Addendum No. E-1
To Mechanical & Electrical Plans and Specifications:
Wagner Hangar
Wagner, South Dakota

Addendum Dated: June 21, 2019

**SUPPLEMENTAL
DRAWING
MESD-1**

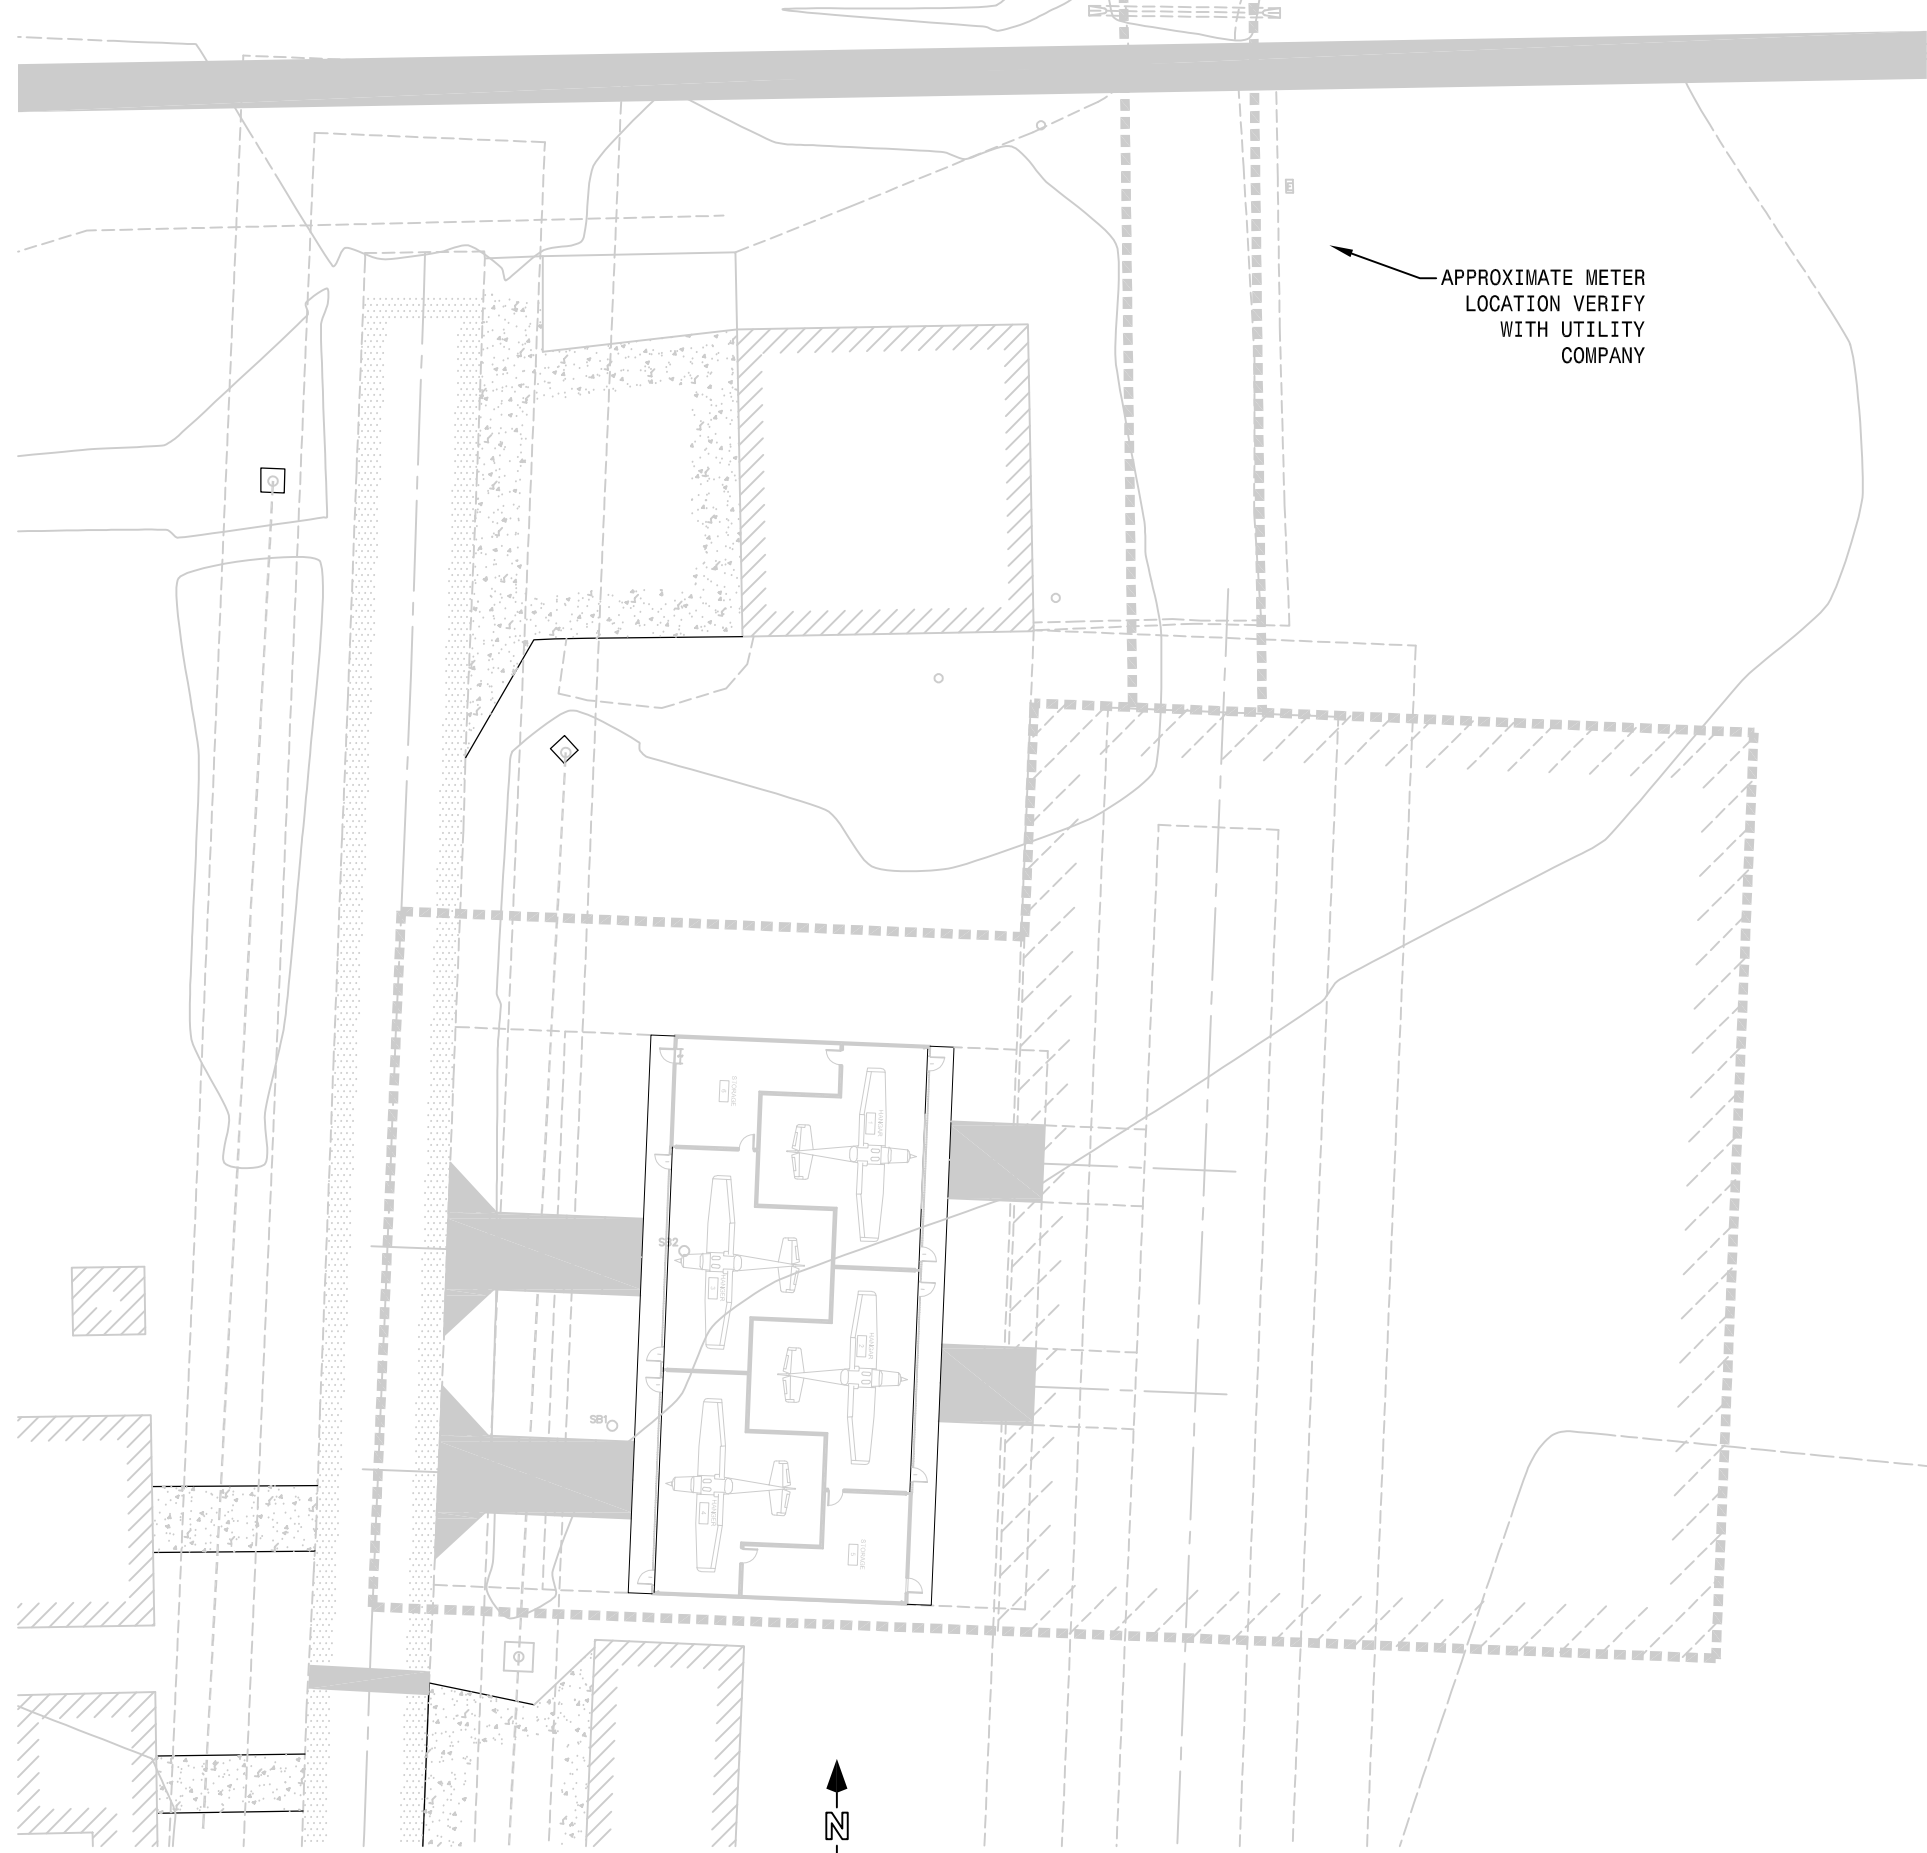
1. Clarification - See attached MESD-1 for meter location.
2. Change to feeder sizes – sheet E4 – feeder note #1 is “2-1/2 inch conduit with (3) 250 AL.”
3. Change to feeder sizes – sheet E4 – feeder note #5, the meter socket is provided by the utility company.

APPROXIMATE METER
LOCATION VERIFY
WITH UTILITY
COMPANY
